ANNEX A

C-111

**LETTERS RECEIVED IN RESPONSE TO THE DRAFT
GENERAL REEVALUATION REPORT
AND
ENVIRONMENTAL IMPACT STATEMENT**

RE: U.S. Army Corps of Engineers Draft Integrated General Re-evaluation Report (GRR) and Environmental Impact Statement (DEIS) on the Central and Southern Florida Project - Canal 111 (C-111) South Dade County, Florida
SAI: FL9403010133C

MODIFIED
ALTERNATIVE 6A

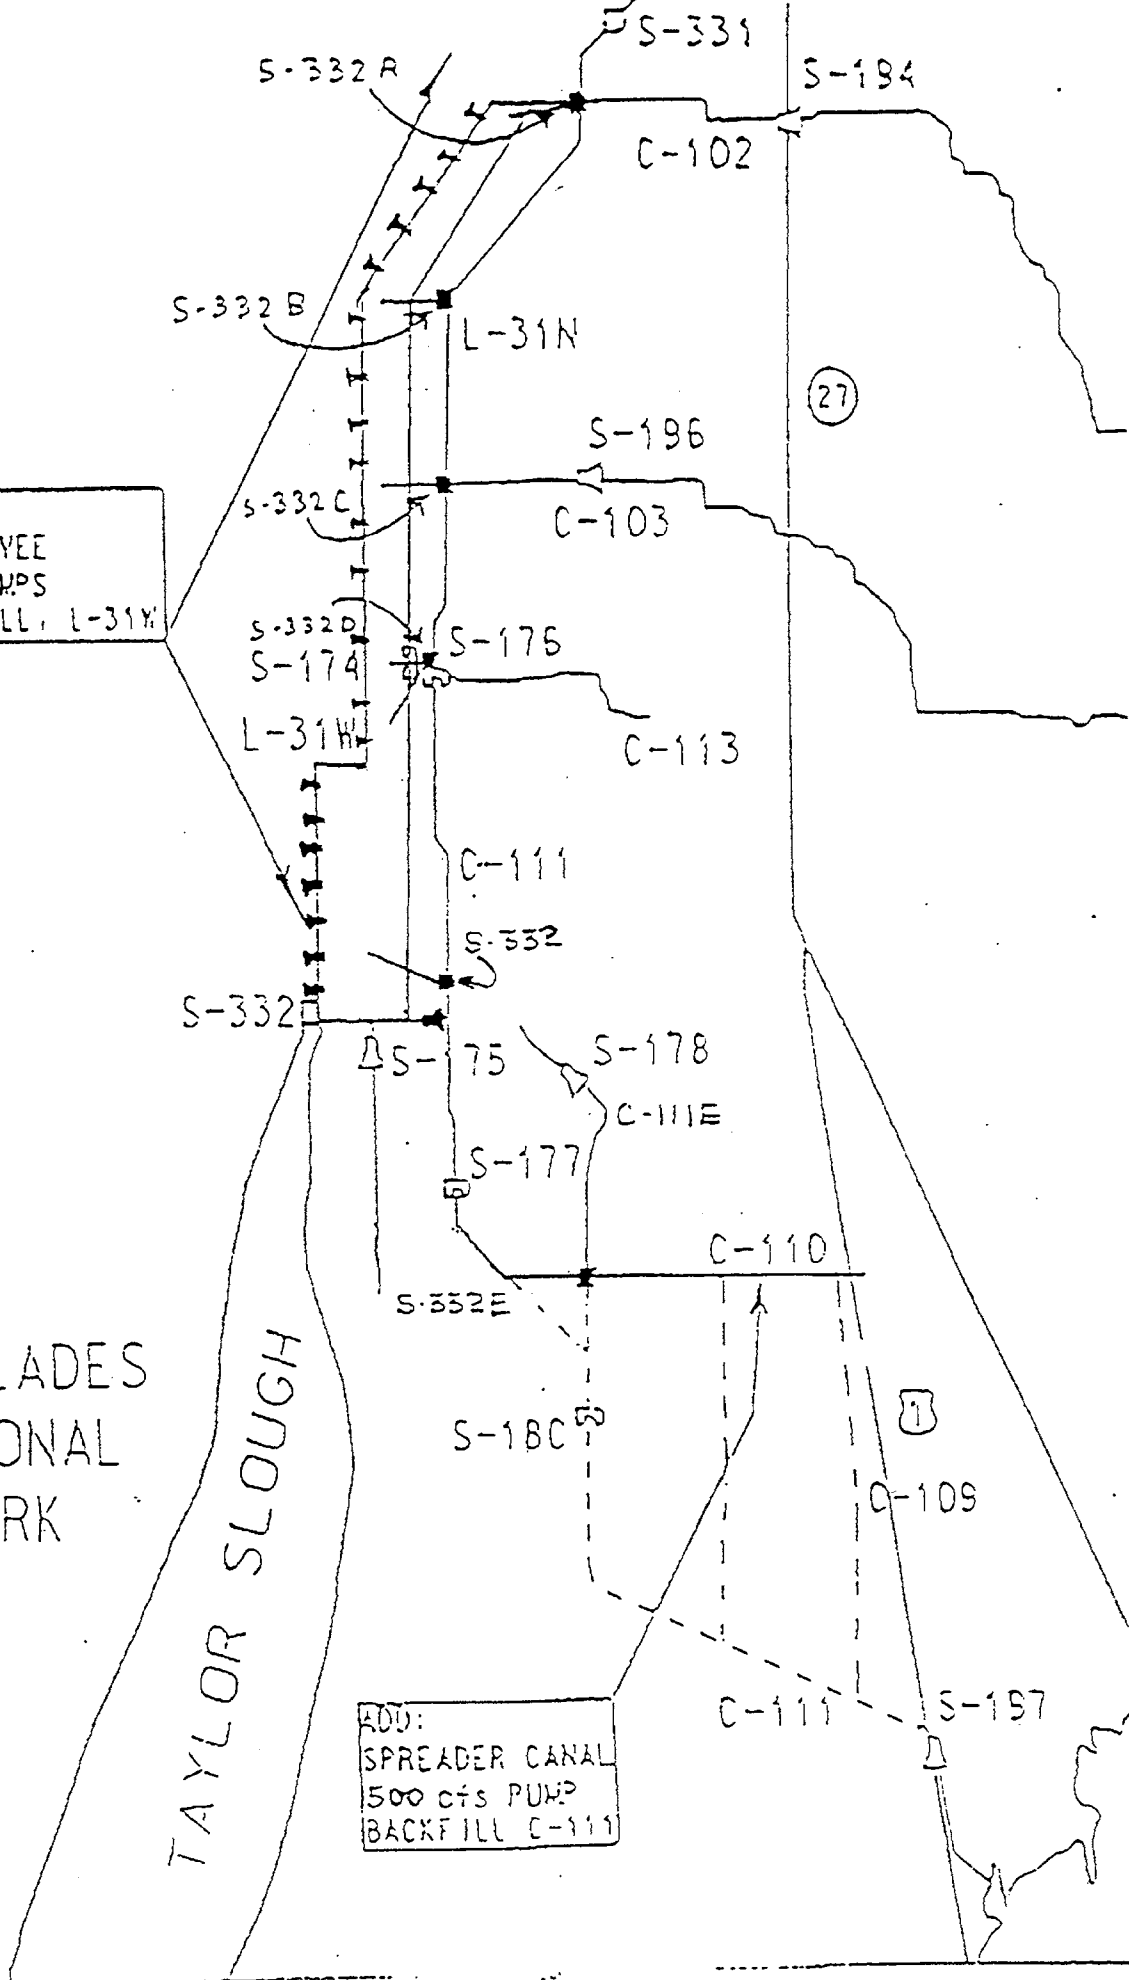
The Corps' preferred Alternative 6A does not go far enough toward accomplishing this objective. However, we believe that this alternative could be improved significantly with further modification and improvement (cf. enclosed figure). Specifically, a 500 cfs pump (S-332E) should be located on the C-111E Canal and discharge to a spreader canal which extends east at the north end of the C-109 and C-110 Canals and passes under U. S. Highway 1. This feature would increase the ability to disperse water in a more natural manner into existing wetland areas. Filling of the C-109 and C-110 Canals would prevent the short-circuiting of marsh sheet flow.

ADD:
NORTH/SOUTH LEVEE
5-300 cfs PUMPS
PARTIAL BACKFILL, L-31W

ADD:
SPREADER CANAL
500 cfs PUMP
BACKFILL C-111

Figure 1

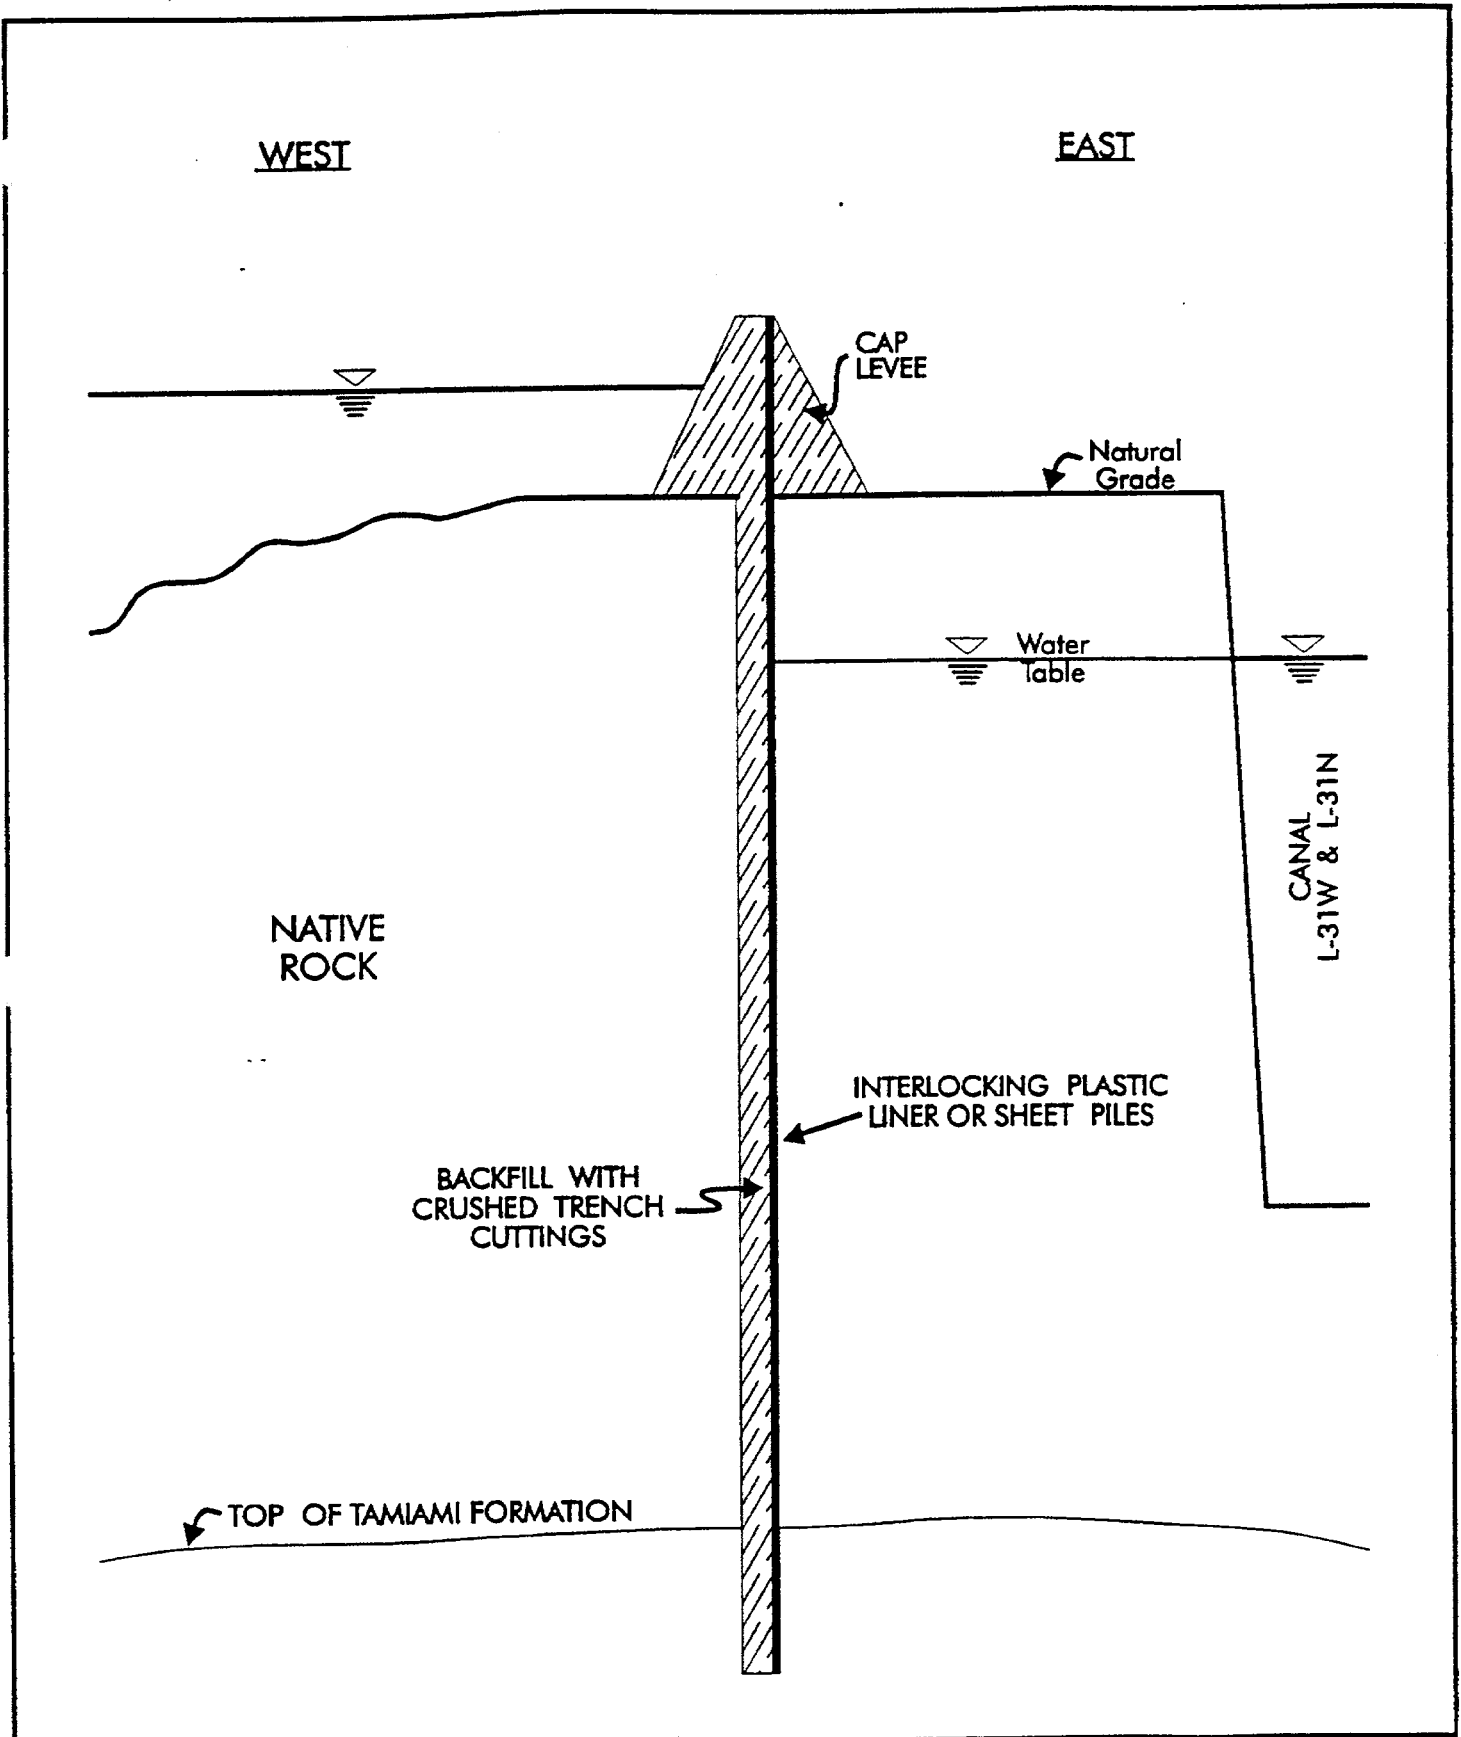
Figure 1 shows a vertical section of the proposed concept. It consists of a vertical trench through the limestone with a plastic liner inserted along the eastern side of the trench face. After placement of the material, the trench would be backfilled with trench cuttings. The liner material could consist of 120 mil plastic liner material with interlocking joints. For areas where this material is not appropriate, due to small to medium sized solution cavities, a plastic sheet pile can be used instead and interlocked with the liner material if necessary. In situations where neither is appropriate, it may be necessary to leave a local gap in the curtain wall. It should be remembered that the concept consists of reducing regional flow and leakage associated with localized openings is not considered to be significant.

The section in Figure 1 shows the liner fully penetrating to the less permeable Tamiami Formation, which varies in depth from about 40 to 55 feet along the proposed alignment. However, this need not be the case because its purpose is to reduce, not stop, leakage from the park. If the concept works too well and additional easterly flow is desired, then gated culverts through the cap levee could be used to move water from west to east. In addition, it would be possible to remove panels from the curtain wall if more flow is required.

Proposed Alignment

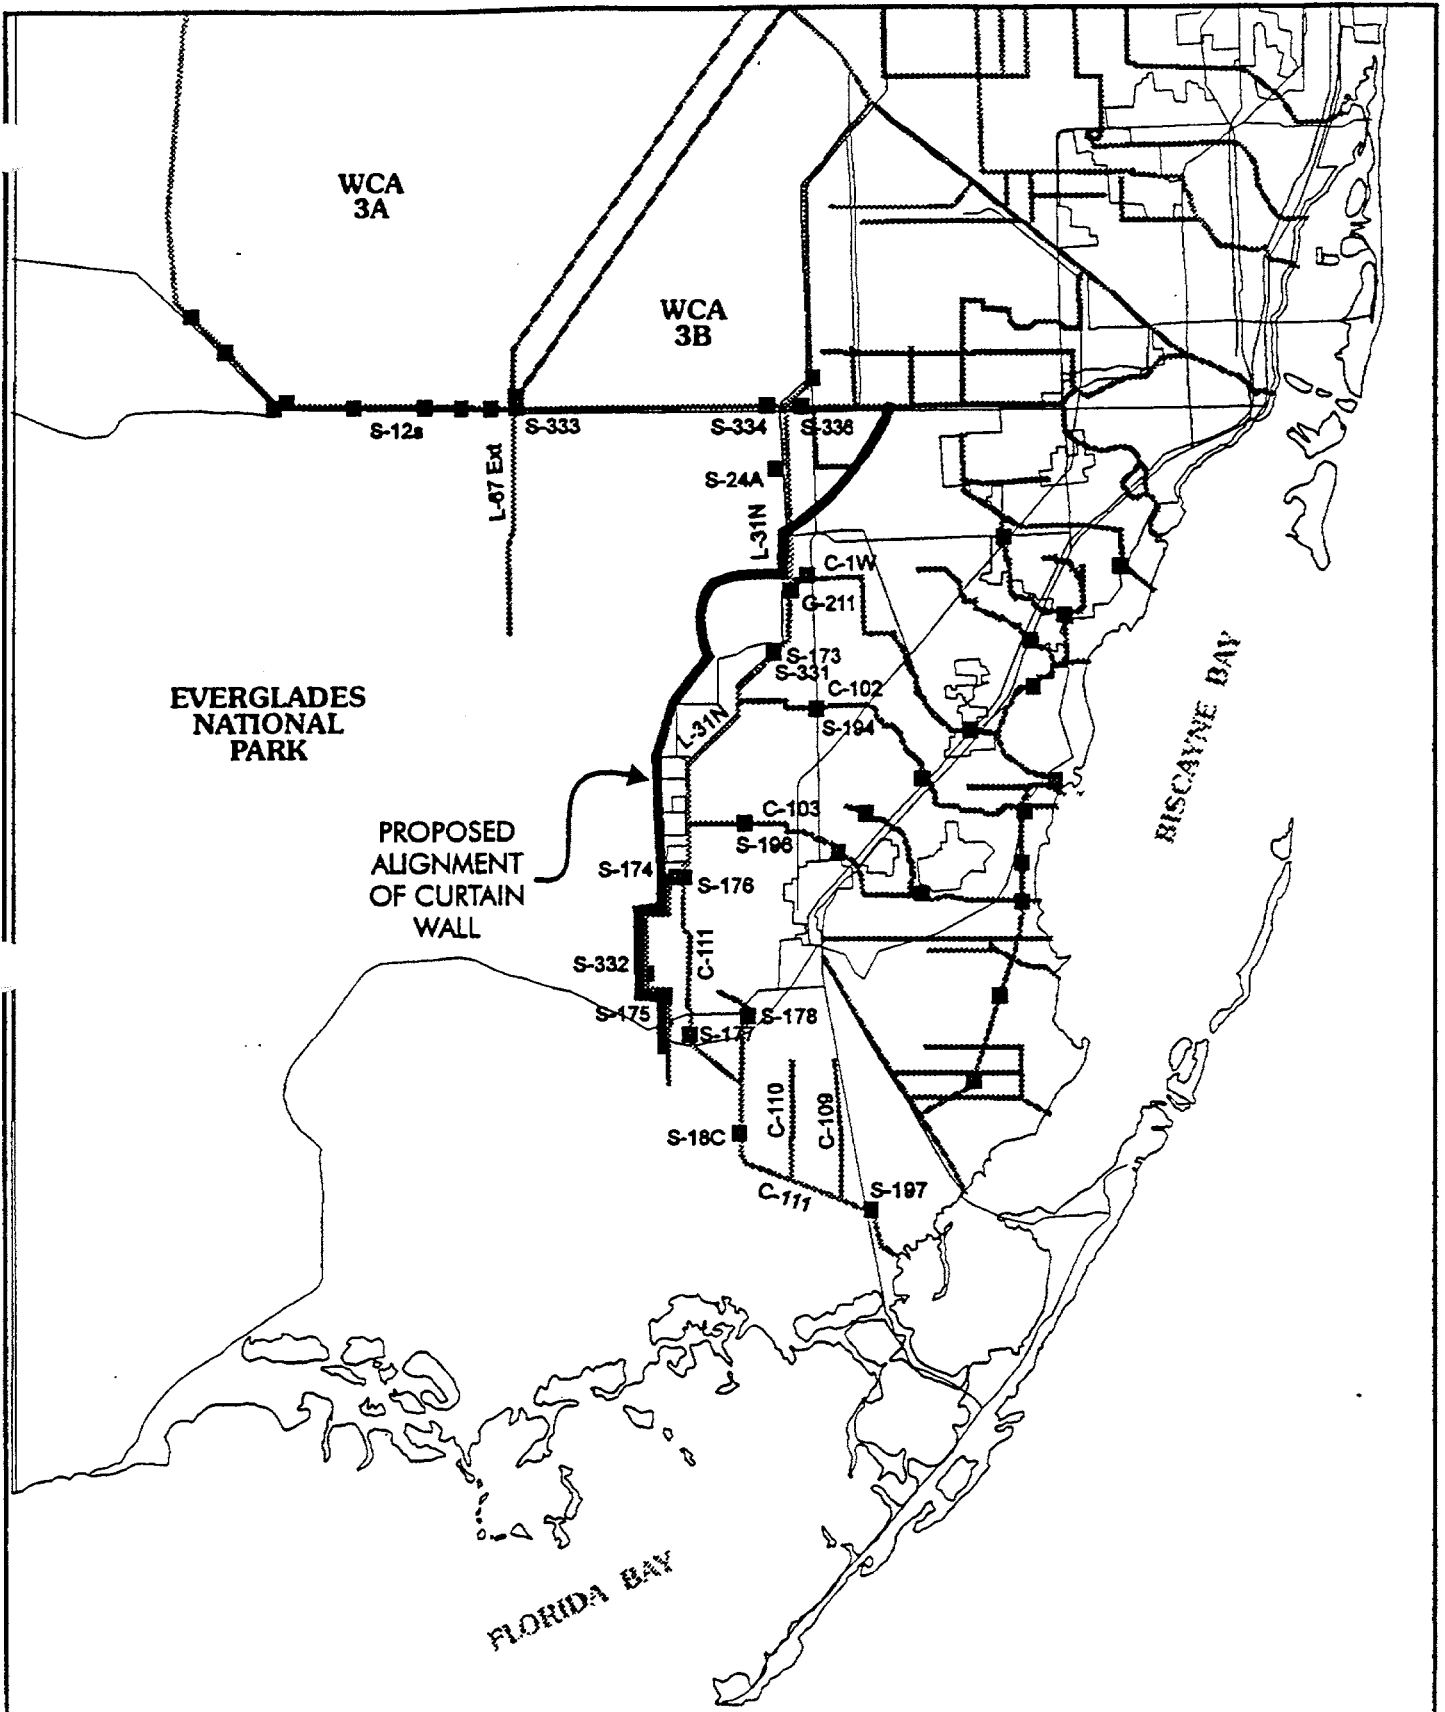
The proposed route for this facility is shown in Figure 2. It would begin at the southern boundary of the Frog Pond and be placed along the western bank of the L-31W borrow canal. North of the Frog Pond, it would follow the same alignment as the western levee proposed in the Corps' Alternative 6. It would also follow the proposed western levee alignment around the 8.5 Square-Mile residential area to the existing the L-31N levee. Structure G-211 would be moved north of C-1W to form a new delivery location for L-31N borrow canal and to make C-1W available for flood control use. The alignment would cross L-31N at G-211 and then follow the eastern bank of the canal (northward) to a point immediately south of the remnant wetlands of the Bird Drive area. From that point, it would skirt the southern side of the wetland area in a northeastern sweep to be terminated at Tamiami Trail.
